# REGIONAL REVIEW NOTIFICATION

**Name of Proposal:** Holly Springs Home Depot Development

**Review Type:** Development of Regional Impact

| Preliminary Report: | June 15, 2006 | <b>DEVELOPMENT OF REGIONAL IMPACT<br/>REVIEW REPORT</b> | Project:         | Holly Springs<br>Homes Depot #928 |

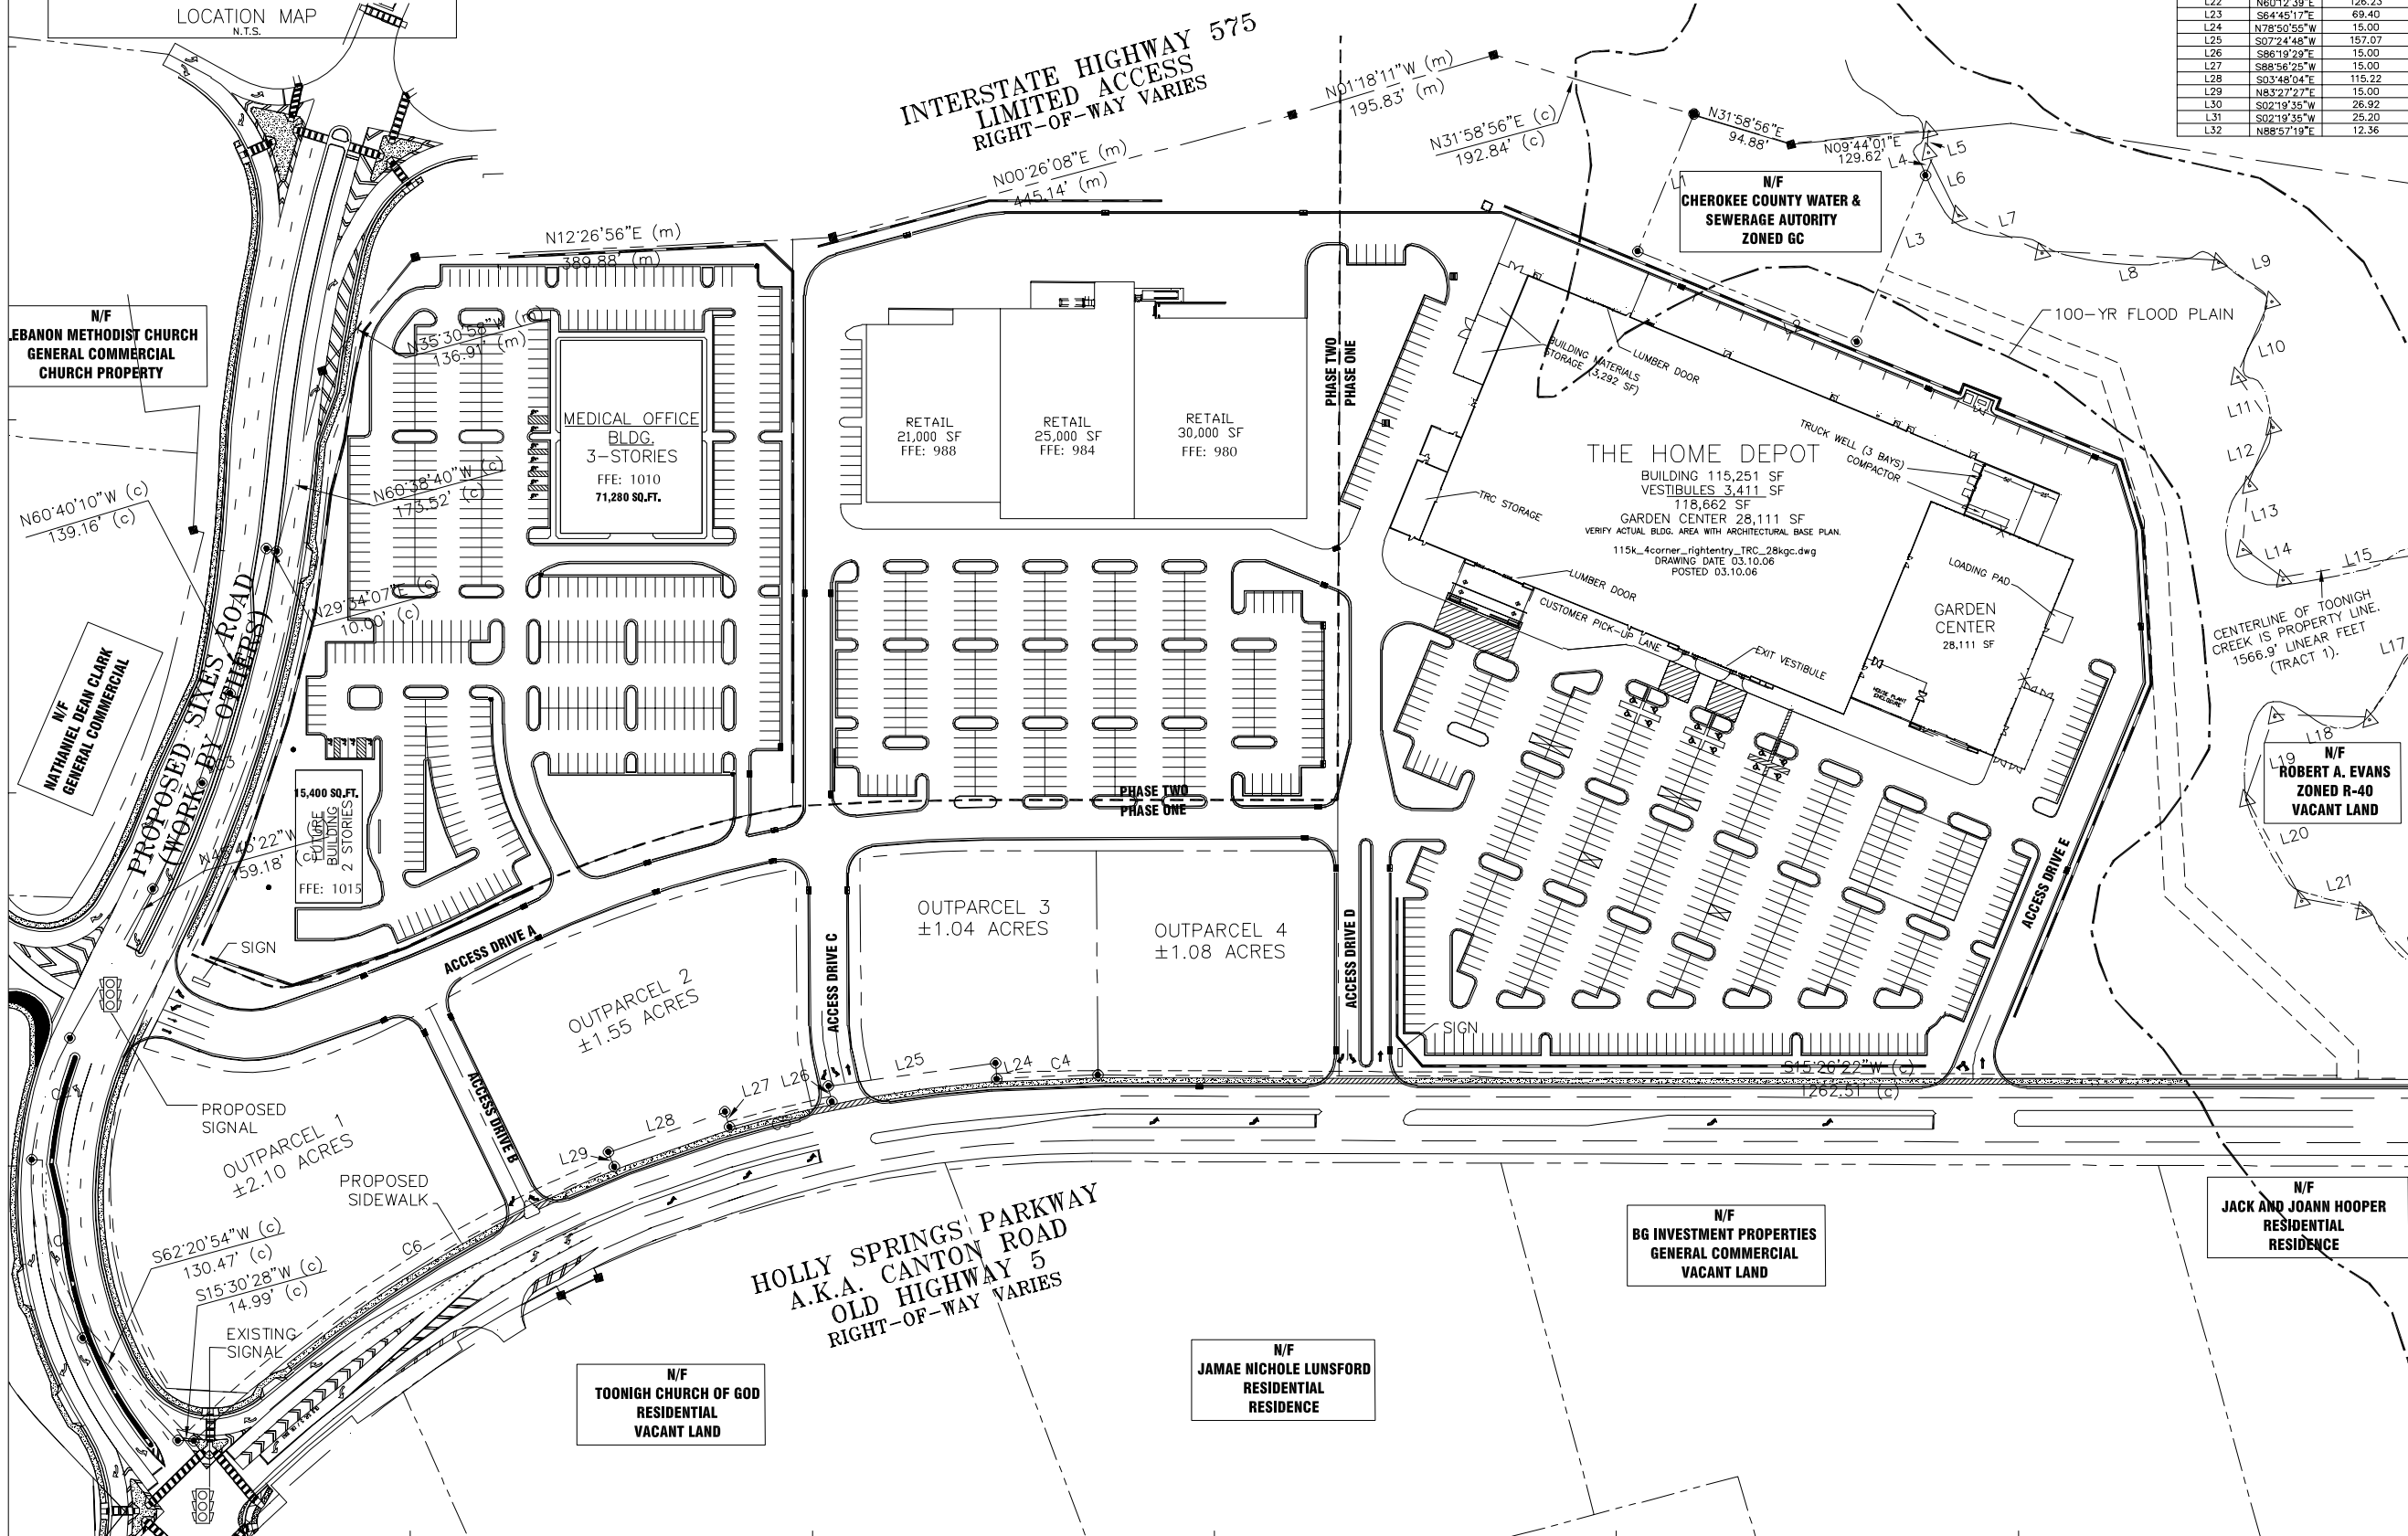
Access management is important to maintaining the long term function and capacity capability of the region's arterial roadways. Therefore, ARC staff recommends that there be no direct access to Holly Springs Parkway and Sixes Road from the outparcels shown on the site plan when future development is proposed.

The northern and northwestern property line is the centerline of Toonigh Creek, which is shown as a perennial (blue line) stream on the USGS coverage for the project area. No stream buffers are shown on the plans but the proposed construction is shown as being 180 feet from the creek at closest approach. The developer should include, and show on all plans, a 50-foot undisturbed buffer and an additional 25-foot impervious surface setback on all streams on the property consistent with the Metropolitan North Georgia Water Planning District's Model Stream Buffer Ordinance, or buffers consistent with any equally protective City of Holly Springs Stream Buffer Ordinance.

The submitted plans show a portion of the proposed development will be in the 100-year floodplain of Toonigh Creek. Development in the 100-year floodplain needs to conform to all City of Holly Springs floodplain regulations. In addition, the project should identify the future-conditions floodplains on the property by performing a detailed flood study using a FEMA-approved model and the projected future land use conditions in the watershed(s) as defined by the local government. For all encroachments into future-conditions floodplain areas, the project should demonstrate that the encroachments will cause no adverse impact (i.e. no increase in base flood or future-conditions flood elevations more than 0.01 foot and no change in depth and velocity) from floodwaters either downstream or upstream by performing a step-backwater analysis using a FEMA-approved methodology. In addition, the project should show that floodplain storage capacity is not diminished by floodplain cut and fill.
